**CALIFORNIA ENVIRONMENTAL QUALITY
ACT (CEQA) ADDENDUM
CITY OF CARLSBAD, CALIFORNIA
PRECISE DEVELOPMENT PLAN AND DESALINATION PLANT PROJECT
FINAL ENVIRONMENTAL IMPACT REPORT (EIR 03-05)**

*State Clearinghouse No. 2004041081
EIR Certified June 13, 2006*

August 2009

Figure 1 - Desalination Plant and Pipelines Map

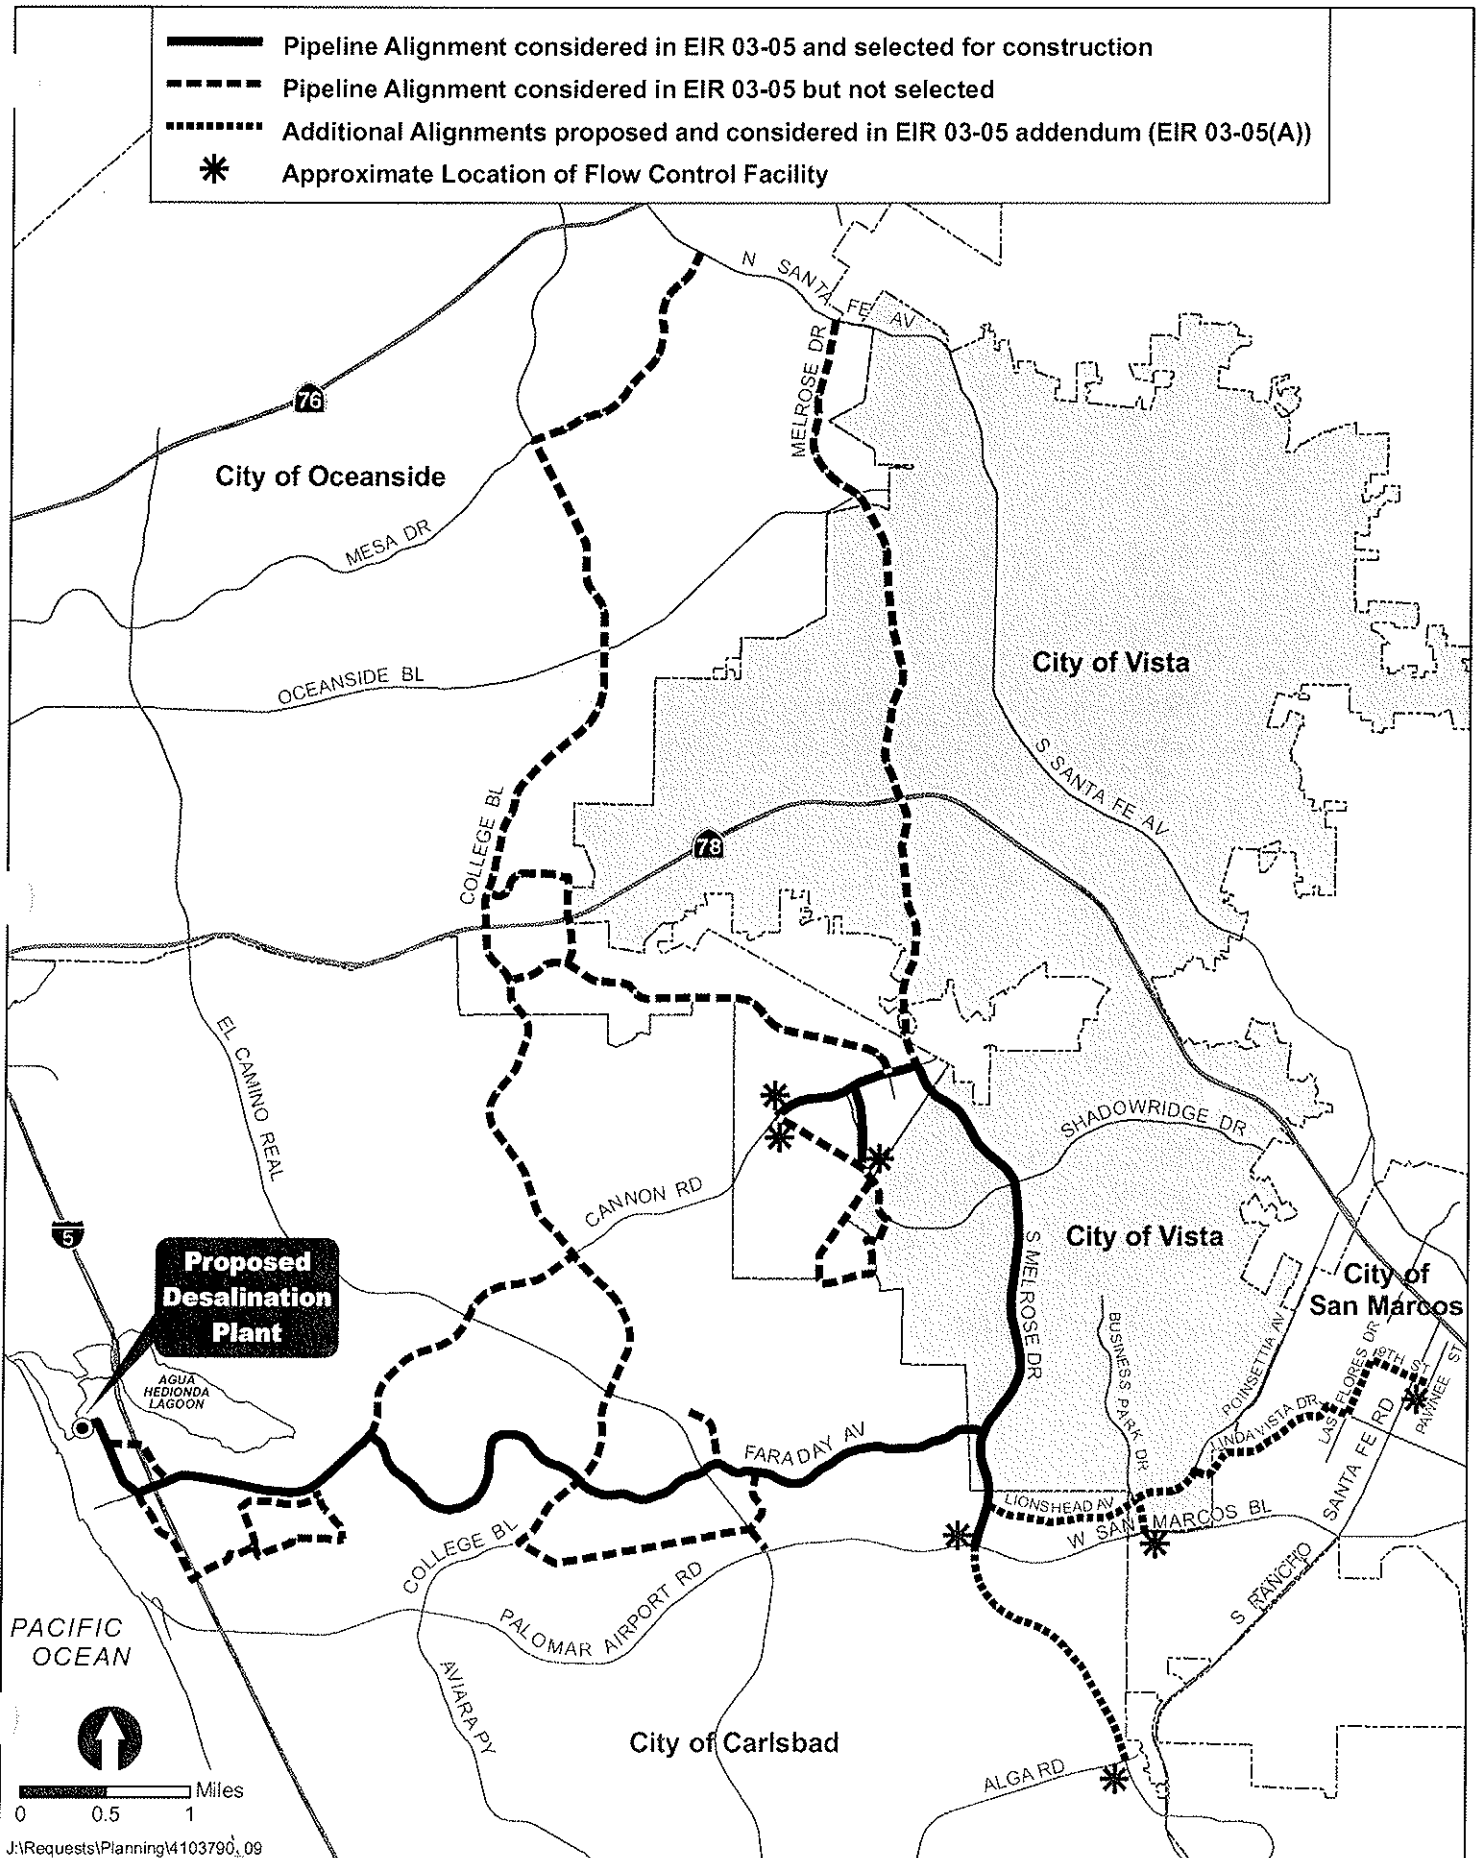
The revised off-site water delivery pipeline route now proposed for construction is less extensive than that addressed in the FEIR. Generally the revised pipeline route would follow only part of the "blue alignment" identified on Figure 3-5 of the FEIR and additional new pipelines described below. Figure 1 shows the various alignments studied in the FEIR, as well as the minor changes and additions addressed in this Addendum.

Delivery of desalinated water from the Carlsbad Seawater Desalination Plant to the City of Carlsbad and other water customers will be through the product water pipelines indicated in Figure 1. The product water pipelines connect to the municipal or regional water systems at several different points as shown on Figure 1. Flow to Carlsbad and the other water customers is regulated and metered using structures known as flow control facilities (FCF). The FCF is a concrete vault structure which contains the infrastructure necessary to meter and control the flow of water to the municipal and regional pipelines that will distribute the water throughout those various systems. The structures will be placed underground and range in size from approximately 15' wide x 25' long x 11' deep to 30' wide x 45' long x 11' deep. These structures will be placed in either the public rights of way or on property adjacent to the pipeline. Although the exact locations of the FCF vaults have not yet been determined, Figure 1 shows the approximate locations of the vaults along the product water pipeline. The structures not located in the ROW will be placed underground on disturbed or already developed areas and therefore will be no biological impacts from their construction. The FCF structures were previously considered with the construction of the product water pipelines in the FEIR and there will be no new impacts related to these facilities being placed outside of the public rights of way.

EXISTING CONDITION

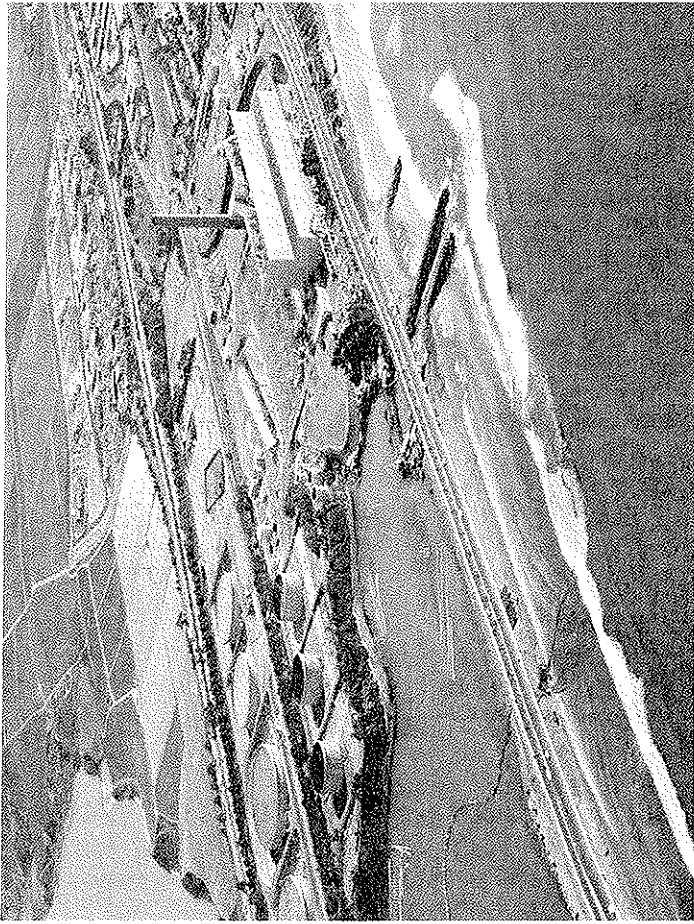
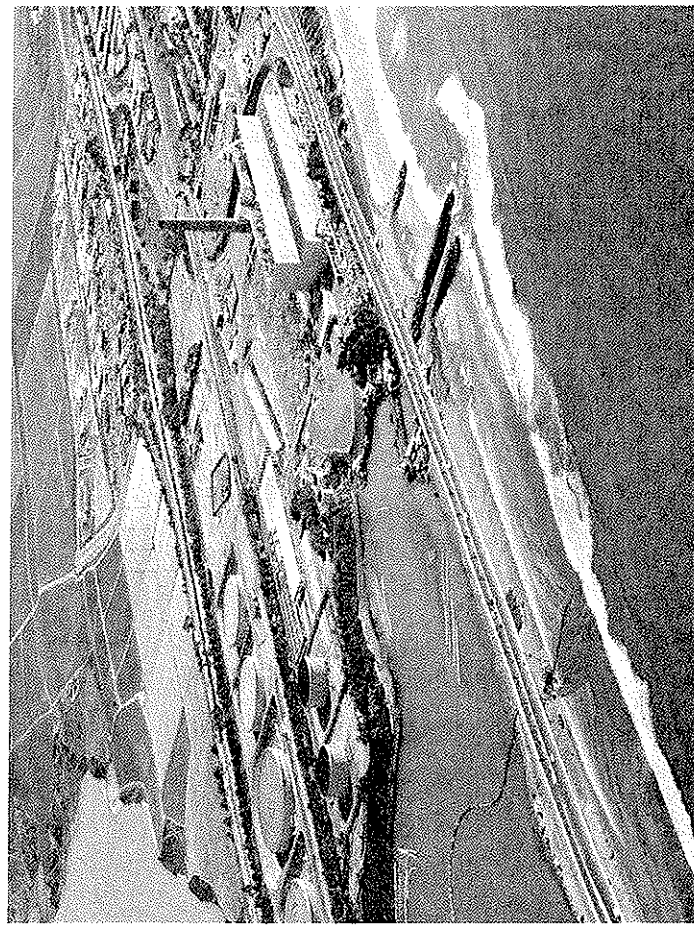
Changes to the proposed design of the Project site will result in an estimated reduction of approximately 44,089 square feet of visible aboveground structures from the Project site. The plant facilities have been reconfigured and consolidated parallel with the existing railroad right-of-way and further set back from the Agua Hedionda Lagoon (See Figures 2 and 3). Pipelines and an intake pump station previously proposed for aboveground installation will be placed underground, including the 72 inch seawater intake pipeline and the 72 inch concentrate discharge pipeline. The pre-treatment pump will be placed in a sub-grade pit and moved to the northwestern corner of the site, visually reducing the pump's size and scale, with additional

The Project as revised will be slightly less visible and further hidden from view from the two ground-level critical viewpoints (Carlsbad Boulevard and Garfield Drive) evaluated in the FEIR. The visual density of the site, primarily as viewed from within the EPS, will be reduced by approximately 25%, with additional structures being placed below ground. The amount of landscaping to further screen the site will be increased. The overall amount of pipelines will be reduced and the need for the 10 MGD booster pump station removed. All previous mitigation measures as discussed in the FEIR will continue to apply.
